Model: Wittke Front Loaders

Subject: Mandatory Fork Cylinder Replacement (HYC00403-03)

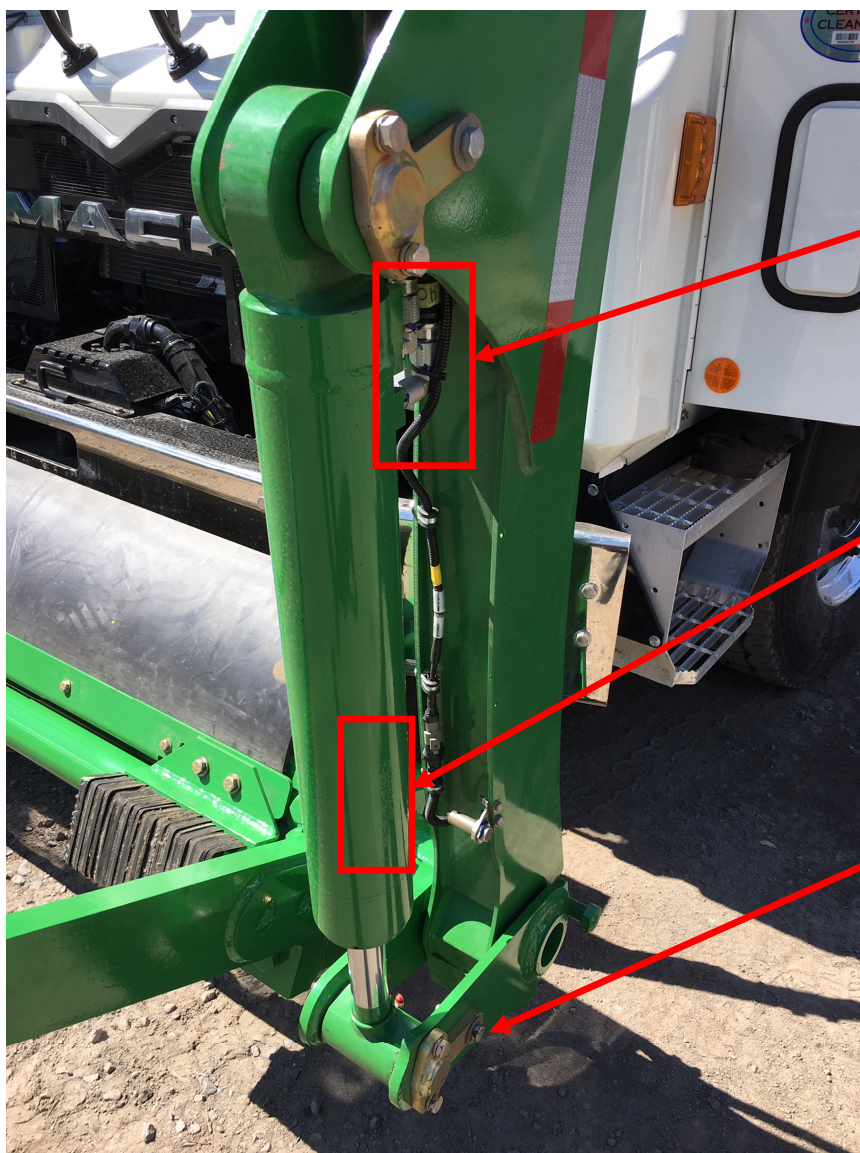
Wittke Fork Cylinders HYC00403-03 were found to be problematic due to an internal leak caused by the piston.

All HYC00403-03 Fork Cylinders with the Part Serial Numbers starting with T-2017-01-XX-XXXX to T-2018-10-XX-XXXX are to be replaced by HYC00403-04. All other Part Serial Numbers outside this range, should not be replaced as they are not targeted by this campaign.

- Complete the attached spreadsheet with:
 - o Old Part Serial #'s (ex: T-2017-XX-XXXX, location of part serial # can be seen in Pic 1)
 - o New Part Serial #'s (ex: T-2019-XX-XXXX)
- Legible photos of the old destroyed Part # and Part Serial #'s
- Send the completed spreadsheet along with the photos to pierre.brisson@labriegroup.com and omarie@labriegroup.com within 45 days of receiving the parts.

Part Serial Number location

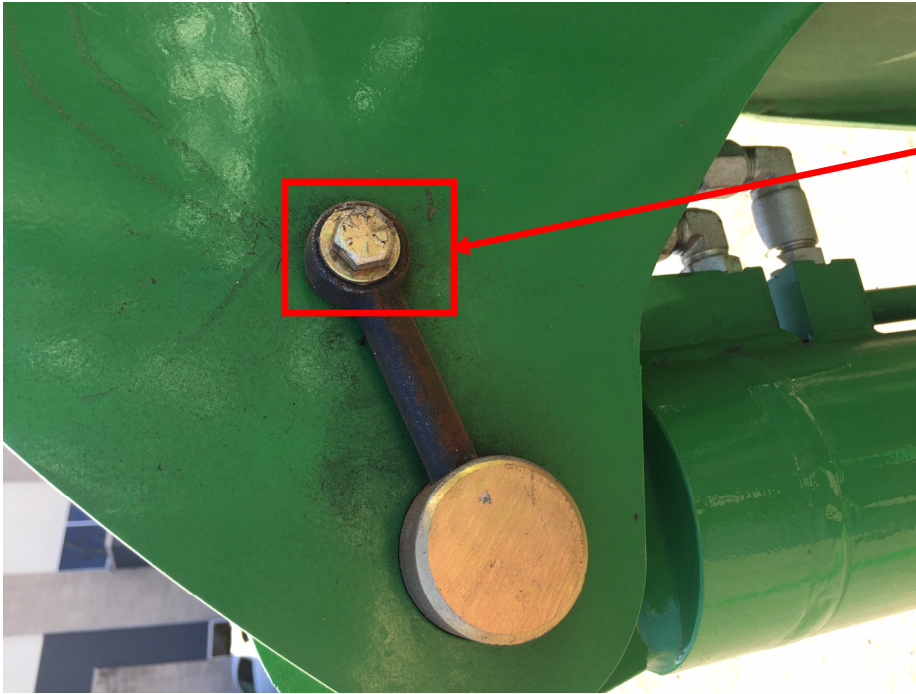
Remove both hydraulic hoses and identify them to make sure they are re-installed at the same location.

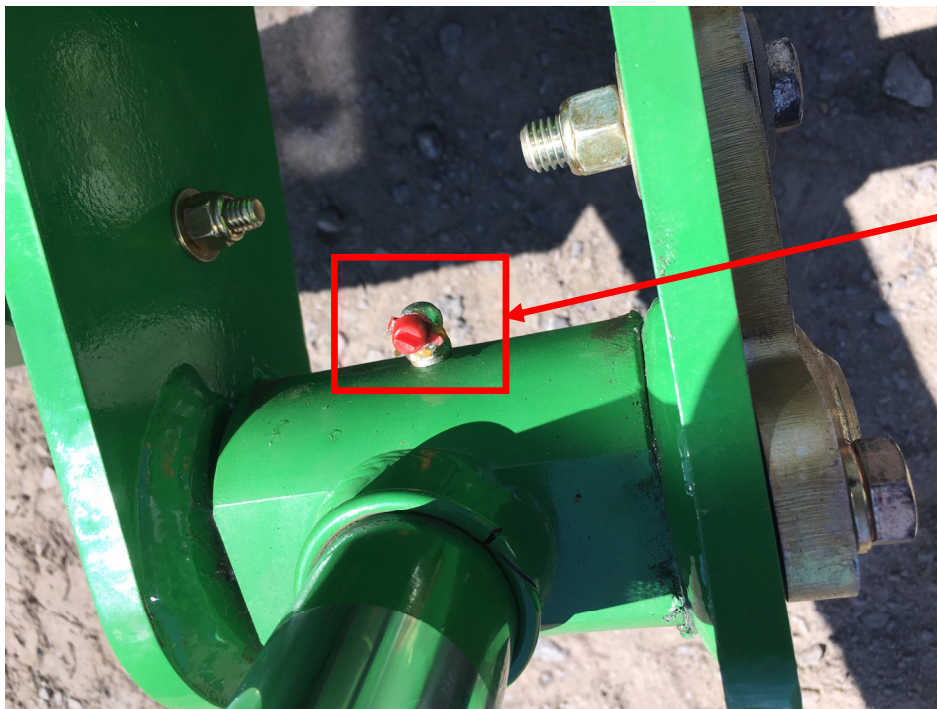
Remove bottom and top pin attachments.
